County Plan No.: S-7-90  
 Project Name: Governors Land - West Island Road BMP #1  
 Stormwater Management Facility: Timber Crib Wall  
 Phase:  I  II  III

Re: Governor's Land - West Island Road BMP # 1  
County Plan No. S-7-90  
Timber Crib Wall  
County BMP ID Code: JR 026

The Environmental Division has reviewed a record drawing set dated April 19<sup>th</sup> 2002 as submitted to our office for the above referenced BMP facility. The record drawing provides as-built information for timber crib wall structure # 1 which is situated in a wooded area east of the cul-de-sac at the end of West Island Road and Lot 22 Travis Pond (2327 West Island Road).

**UPSTREAM ELEVATION (JR026)**  
**PREBBURE TREATED WOOD DRY DETENTION STRUCTURE**  
N.T.S.

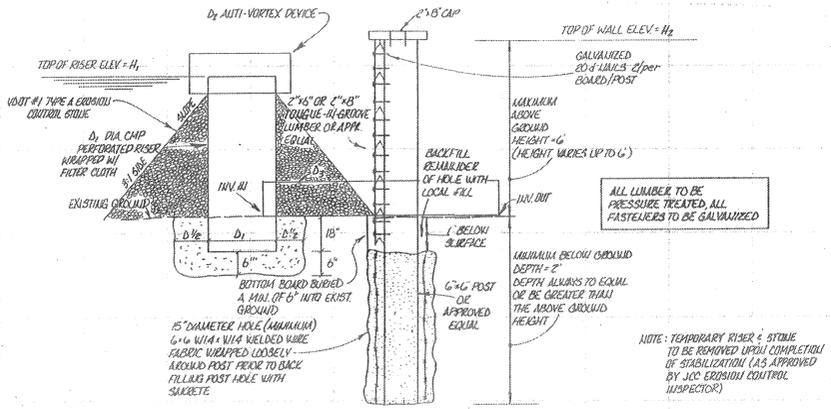
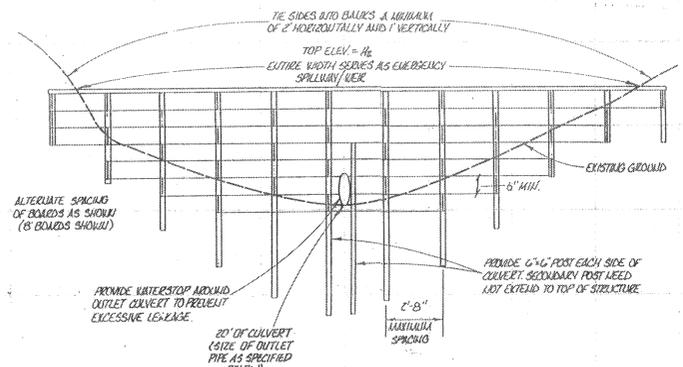
3. Clean and remove excessive accumulations of sediment and debris and completely replace filter stone around the riser. Sediment and debris shall not obstruct flows into the riser structure.

4. A large tree has fallen and severely damaged the timber crib wall near the center of the wall alignment. Clear and remove the fallen tree as appropriate. As significant structural damage has occurred, the wall either needs to be repaired or replaced back to the approved design condition; or alternatively, assessment (and report) by a professional engineer is necessary to ensure that damage did not affect the stormwater function or structural integrity of the extended detention BMP.

5. Repair or replace damaged portions of the riser and barrel structures to a condition meeting the approved design plan. The pipe barrel has disconnected at the last joint and erosion is undermining the wall.

6. Repair severe undercutting which has exposed foundation timbers along the wall.

Restore the outlet protection rock pad to approved design specifications.

The tree has been cleared and removed from the wall and the wall has been stabilized with concrete in the area that had been undermined due to the riser not functioning properly. Stone has been placed over the concrete on the upstream and downstream side of the wall meeting conditions of the approved plan.

Outlet protection has been restored to meet approved plans.
